LOT 32 - SUITE 500

6112 43rd STREET

REVISIONS: 11/17/2008

EXHIBIT "C-1"

FLOOR PLAN
SCALE: 3/16" = 1'-0"

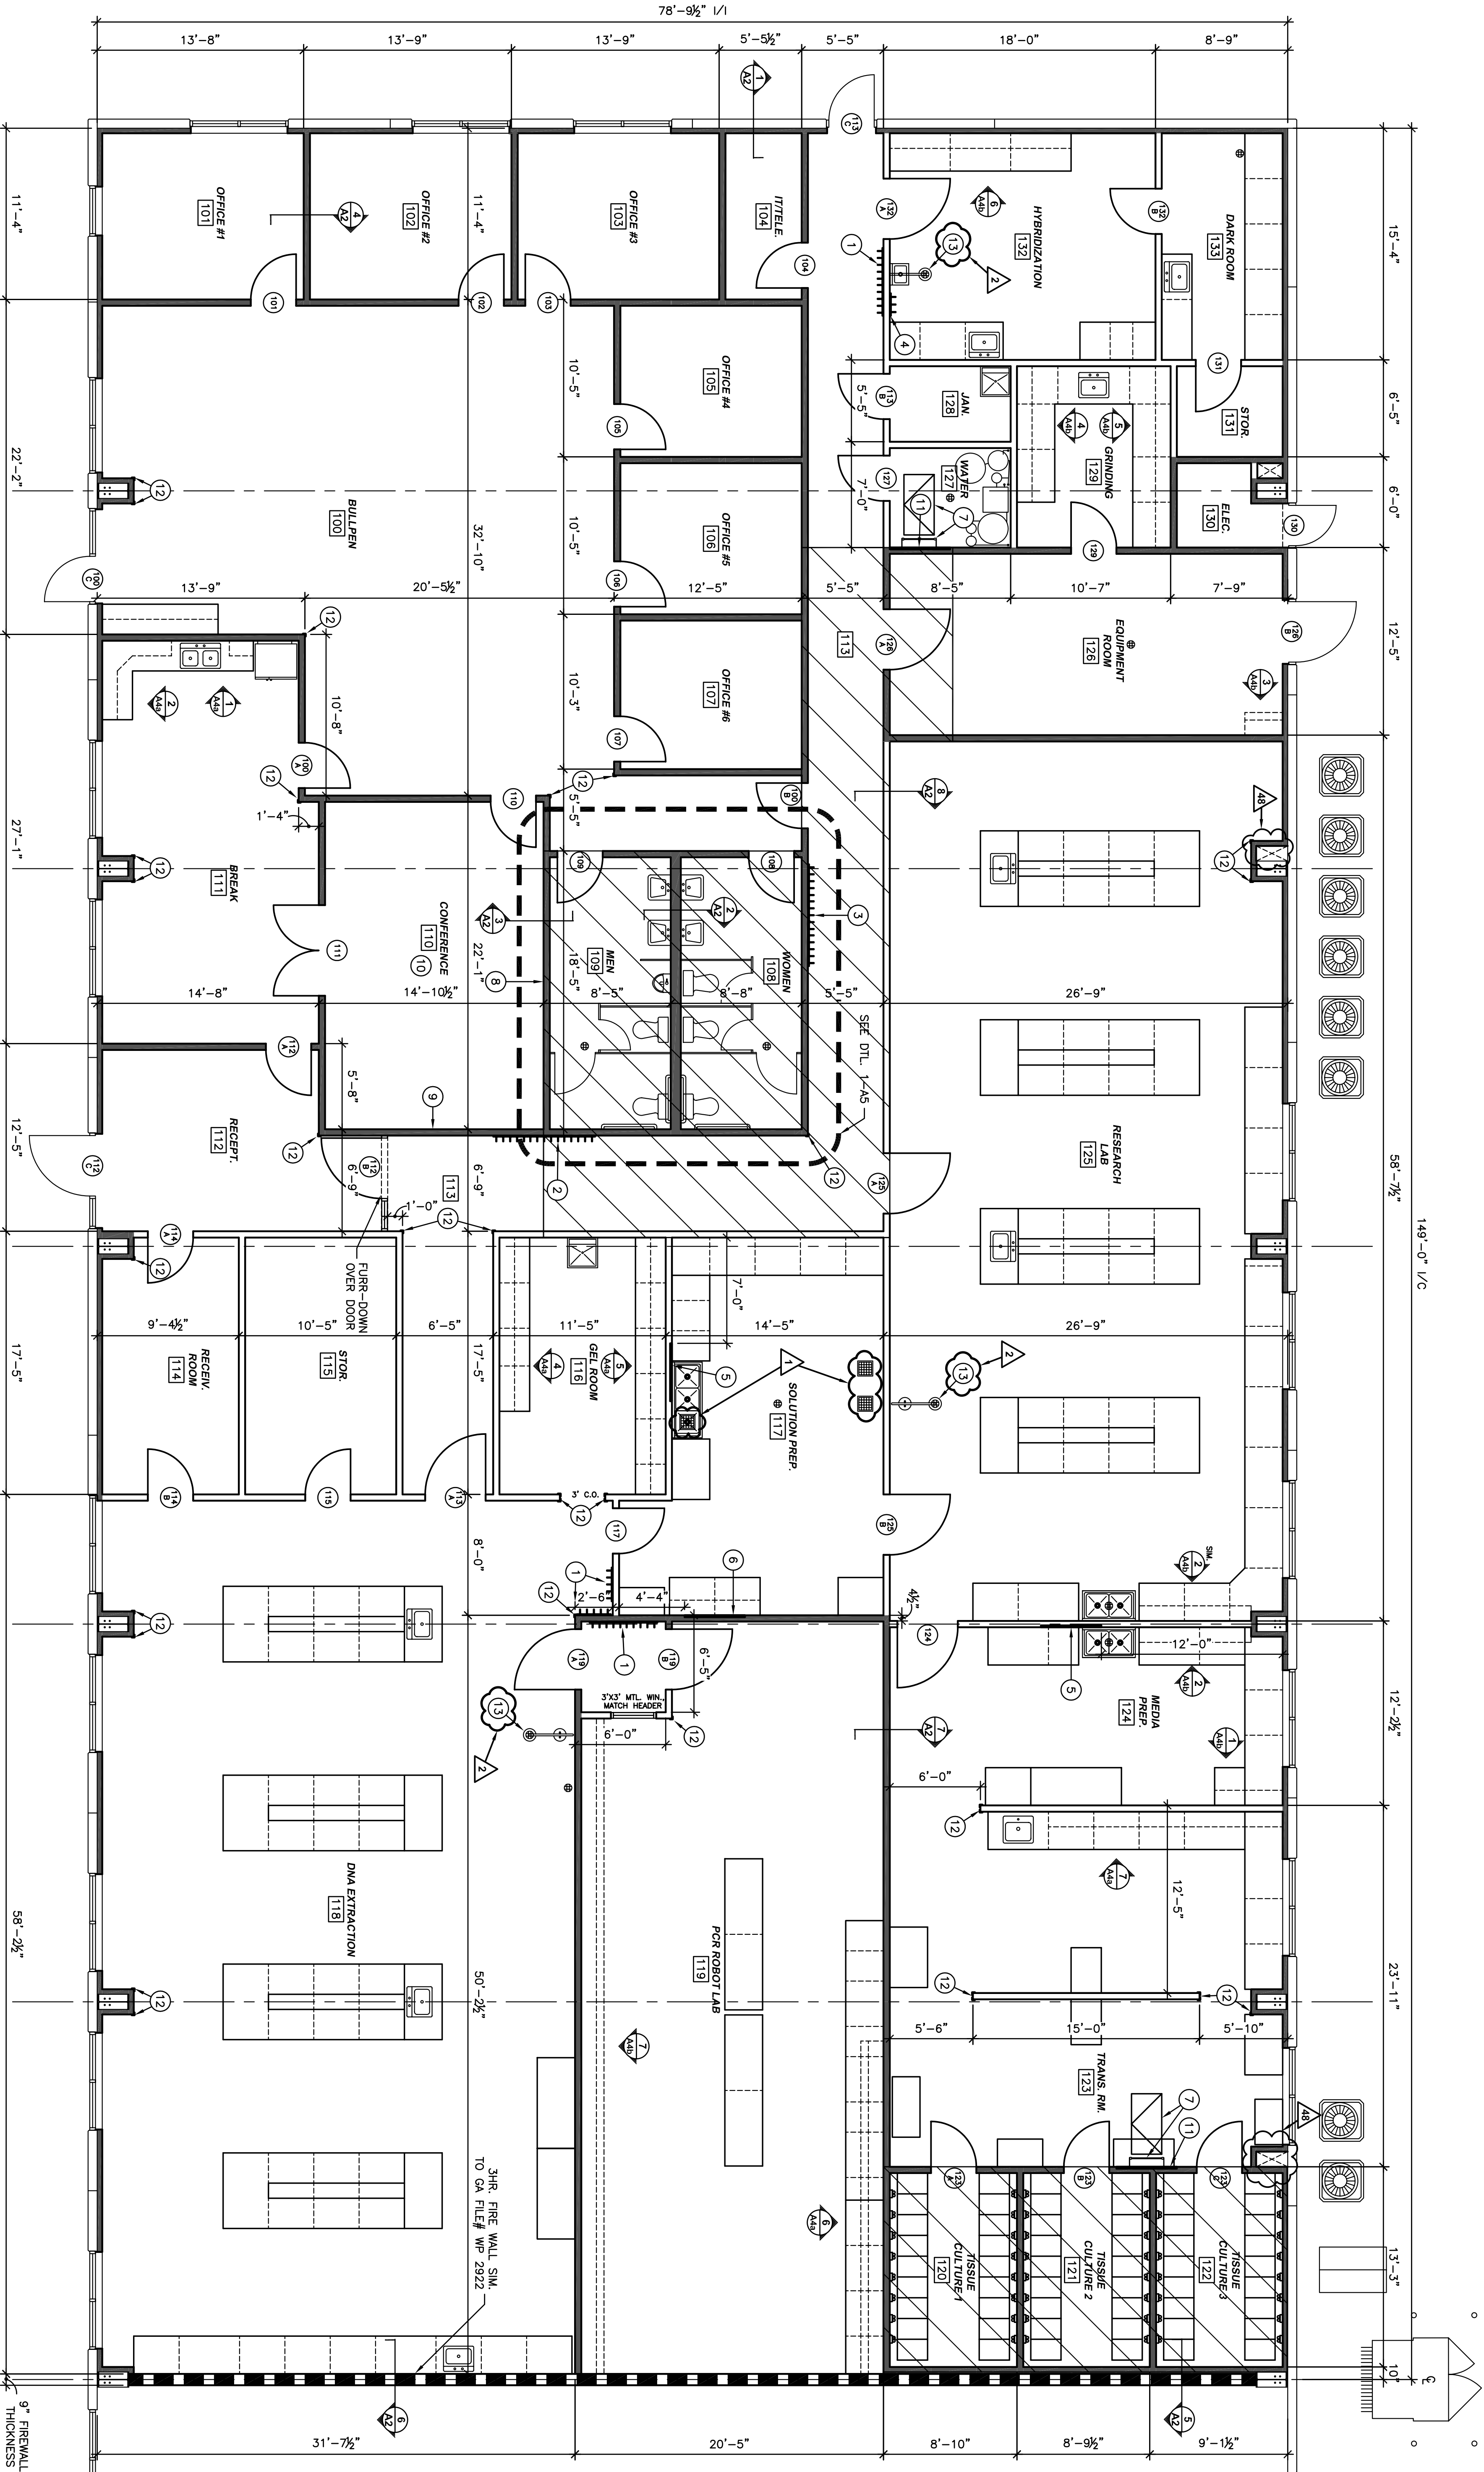
CHANGED (2) F.D. TWO (2) CAST IRON F.S. & (1) STANDARD F.S. IN ROOM 117, SEE SHTS. A1 & P1.
- 2

MOVED BOTH SAFETY-SHOWERS IN ROOMS 118, & 125. CHANGED TO "PROVIDED BY TENANT" & ADD (1) HORIZ. SHOWER ABOVE KNEE OPERATED SINK IN ROOM 132, SEE SHT. A1 FOR LOCATIONS.
- 3

ADDED CHASES FOR HVAC REF. LINES, SEE SHTS. A1 & M1.
- 49

EQUIPMENT/FURNITURE PLAN
SCALE: 3/16" = 1'-0"

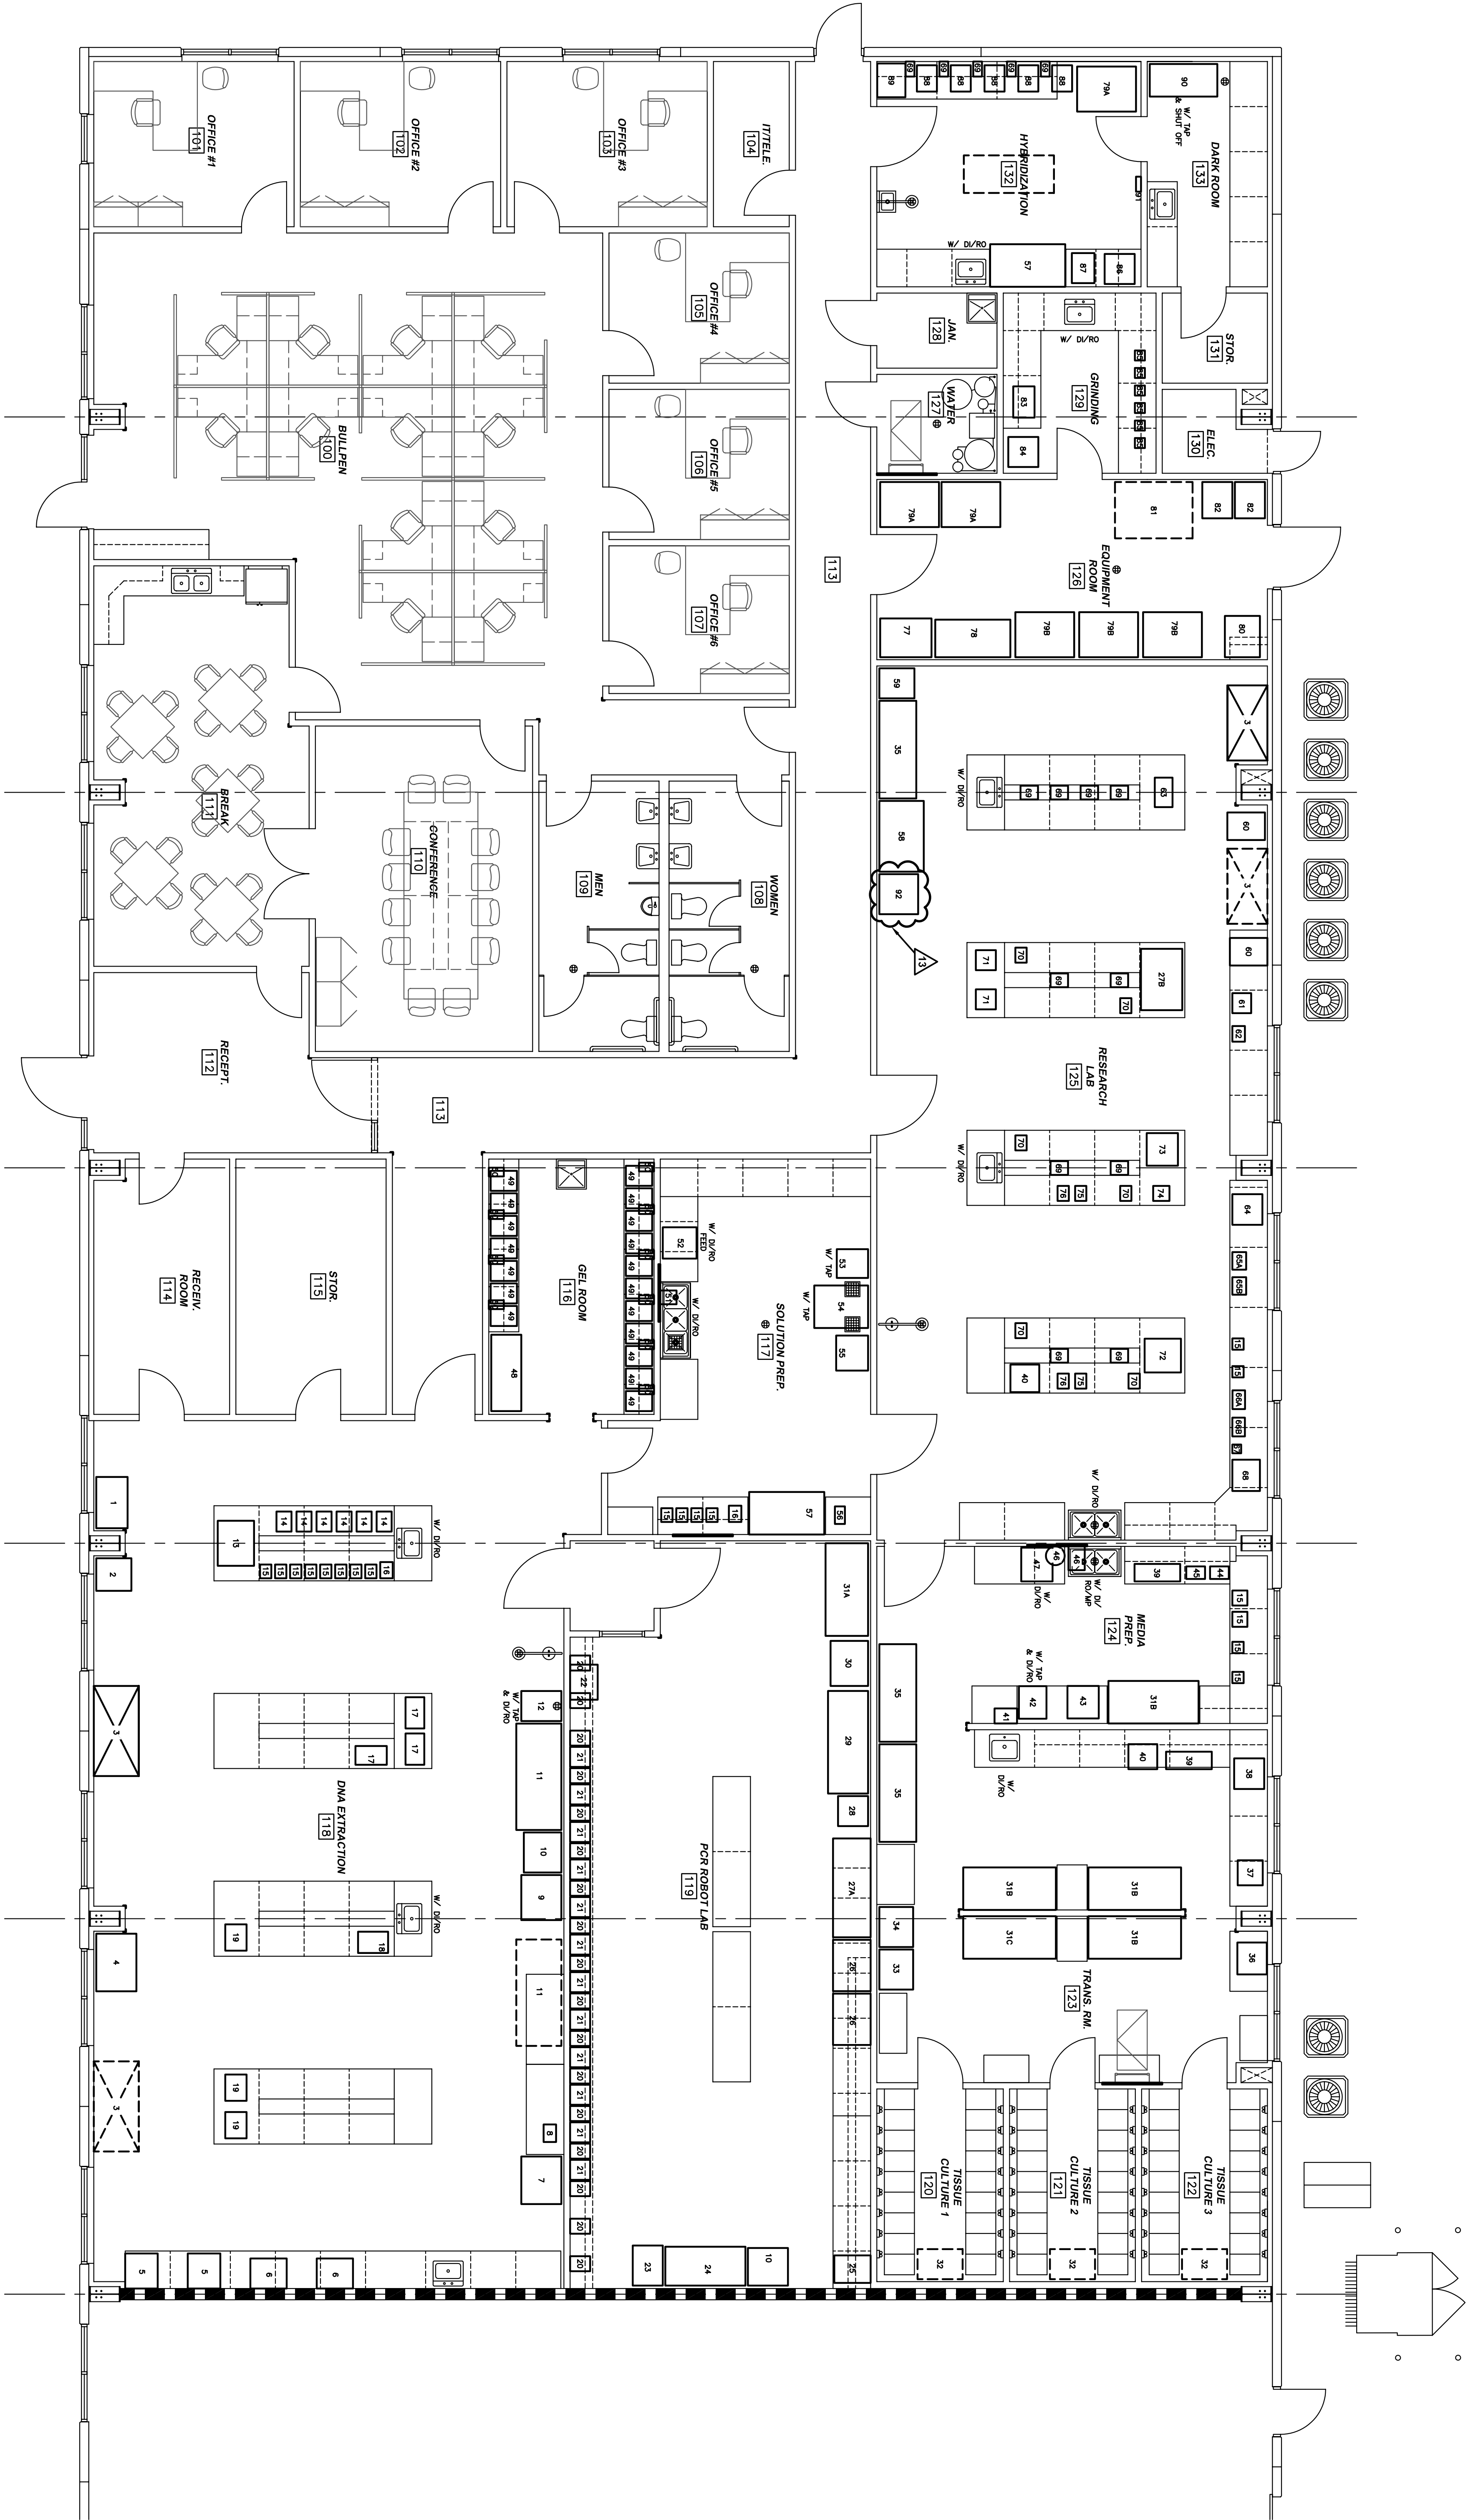
ADDED EQUIP. #92, SEE SHTS. A7d FOR DTLS & SHT. A6 FOR LOCATION.
- 14

REFLECTED CEILING PLAN

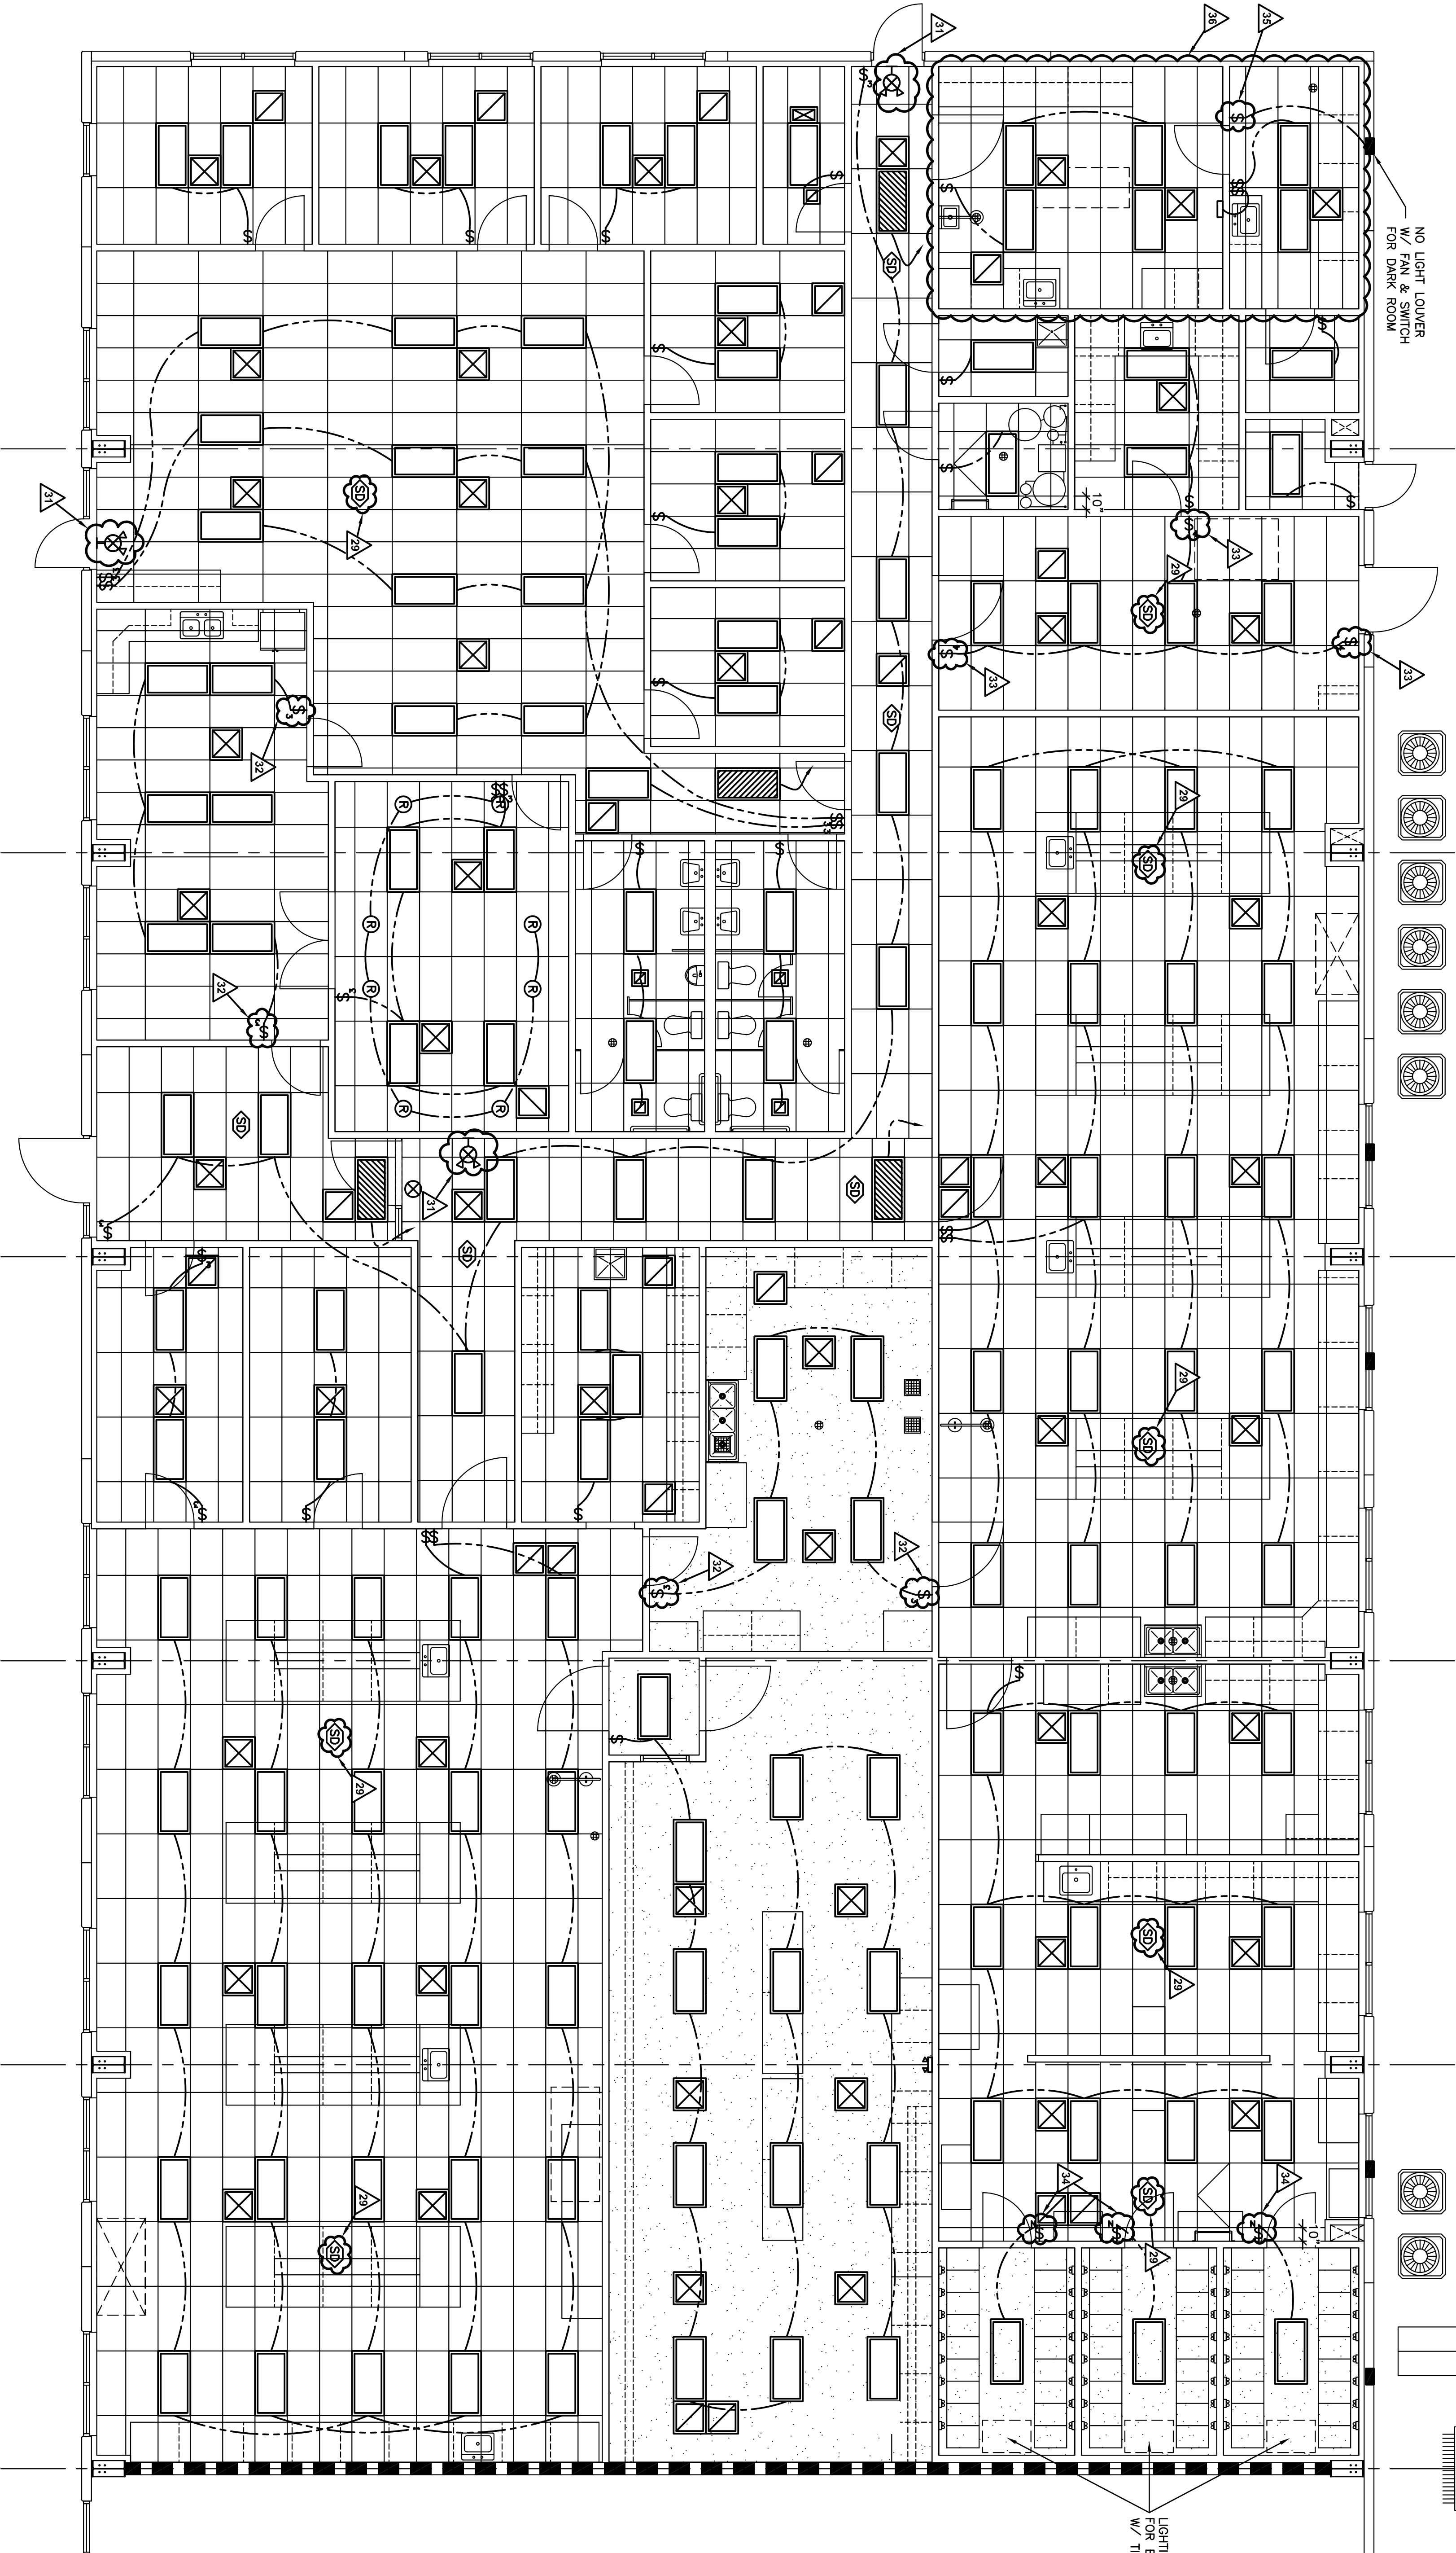
CHANGED (3) EXIT LIGHTS TO INCLUDE BATTERY PACK LIGHTING, SEE SHT. E2.
- 32

ADDED (2) 3-WAY SWITCHES IN ROOMS 111 & 117, SEE SHT. E2.
- 33

ADDED (1) SWITCH IN ROOM 126 TO MAKE ALL SWITCHES 4-WAY, SEE SHT. E2.
- 34

ADDED (3) SWITCHES FOR TISSUE CULTURE ROOMS TO INCLUDE INDICATOR LIGHTS, SEE SHT. E2.
- 35

ADDED FAN SWITCH FOR DARK ROOM 133, SEE SHT. E2.
- 36

CHANGED DRYWALL CEILINGS IN ROOMS 132 & 133 TO LAY-IN CEILINGS, SEE SHT. E2.
- 37
